Re: Addendum No. 1
Nason Basin to Grove Avenue Storm Sewer Phase 1
City of Willoughby

Date: February 25, 2025

Proposal to City of Willoughby
For Nason Basin to Grove Avenue Storm Sewer Improvements - Phase 1
Base Bid
Project No. 150772

12 INCH STORM SEWER & ACCESS ROAD
GRADING PLAN

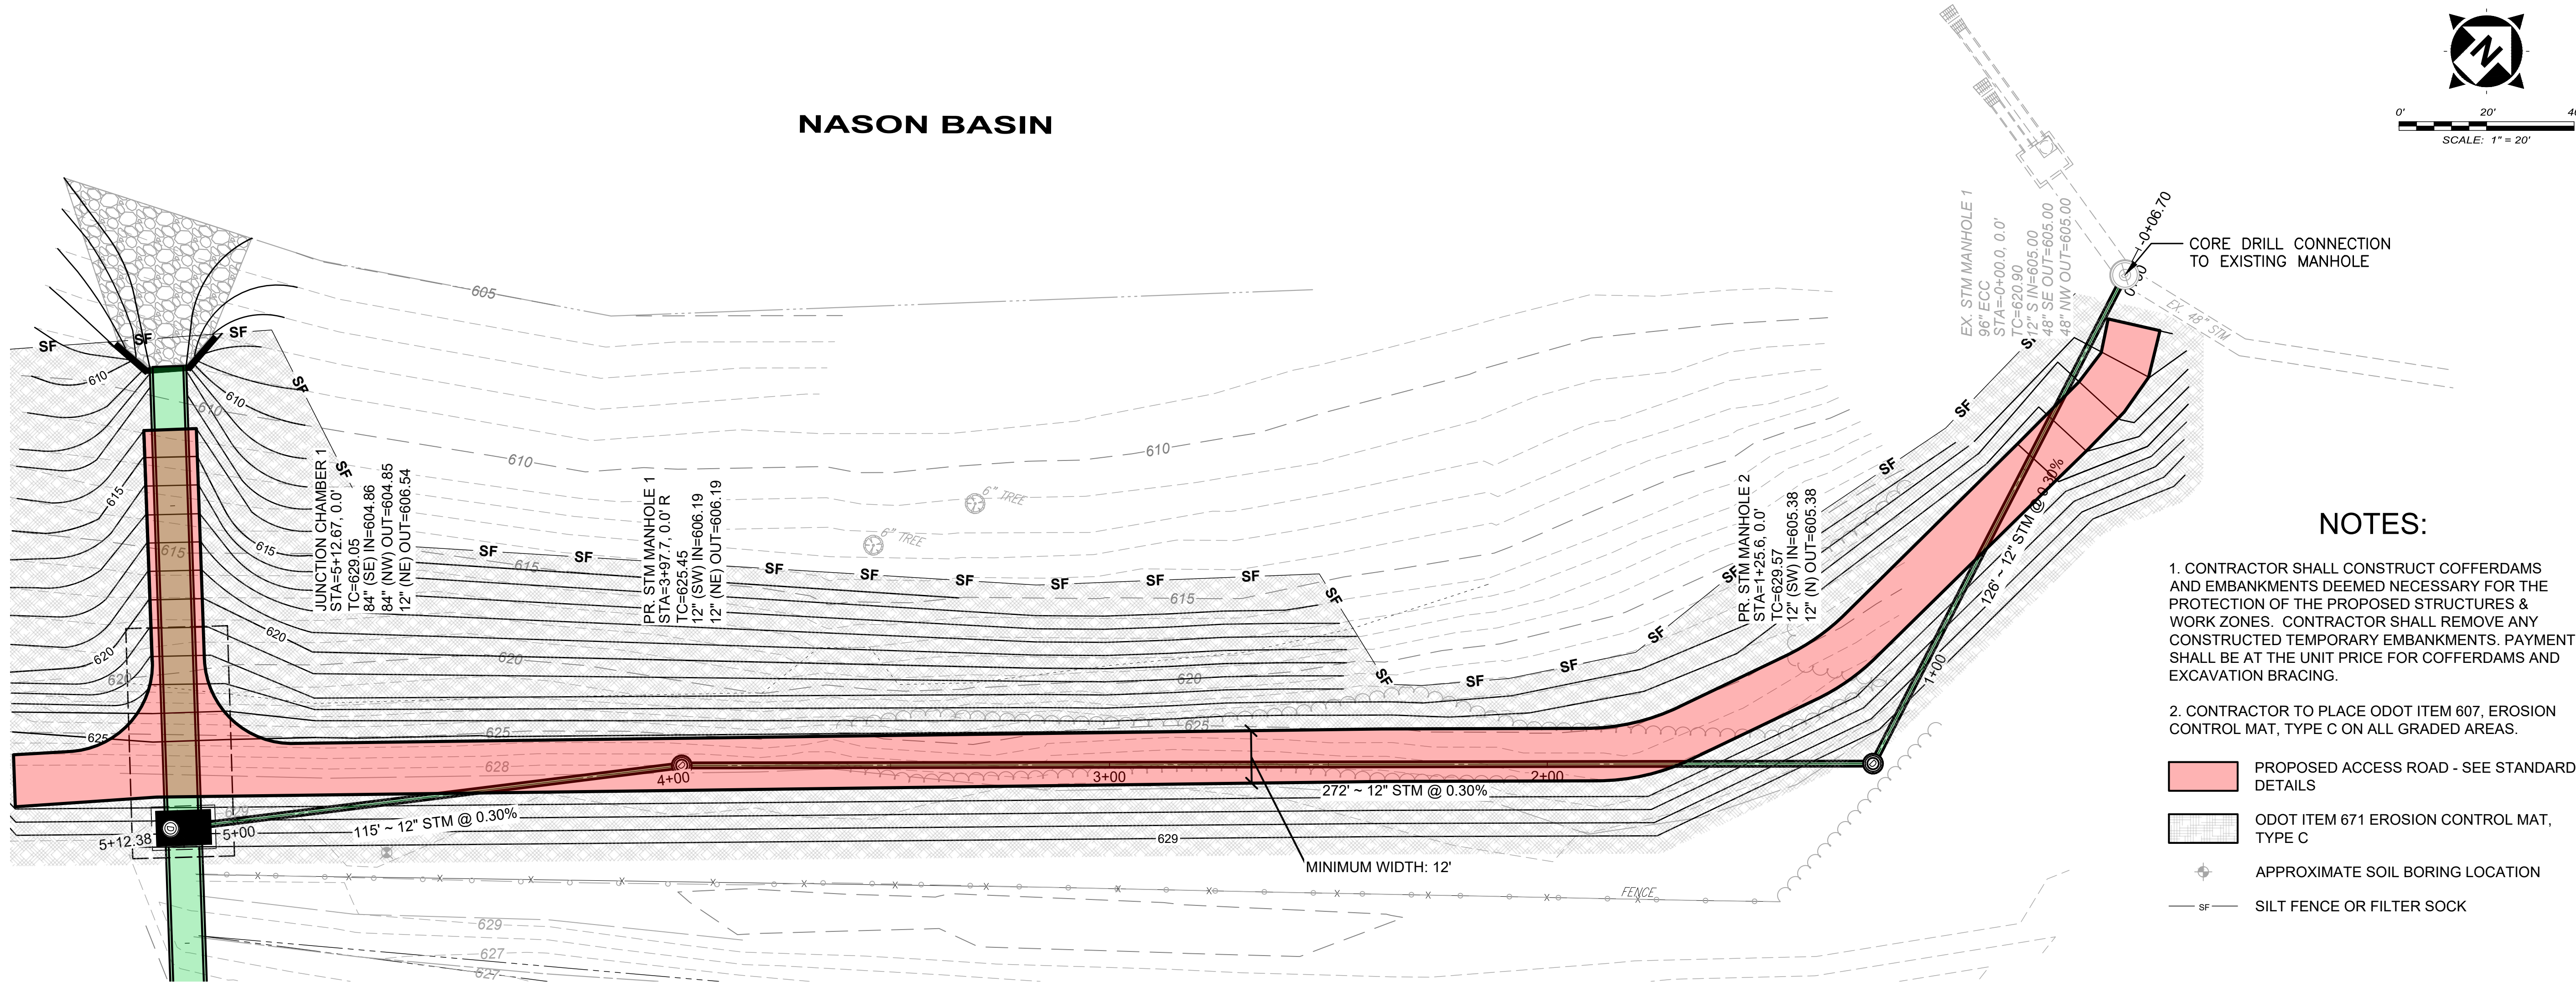
Q4. Is premium backfill going to be required for the 12" sewer run under the access road on sheet 12/43 ? Or can we place and compact the excavated material?

Replace plan sheet 12/43 with the enclosed Revised plan sheet 12/43.

A4. Premium backfill is not required under the access road.

NO	REVISION	DATE
1	Revised in Addendum 01	2/25/25
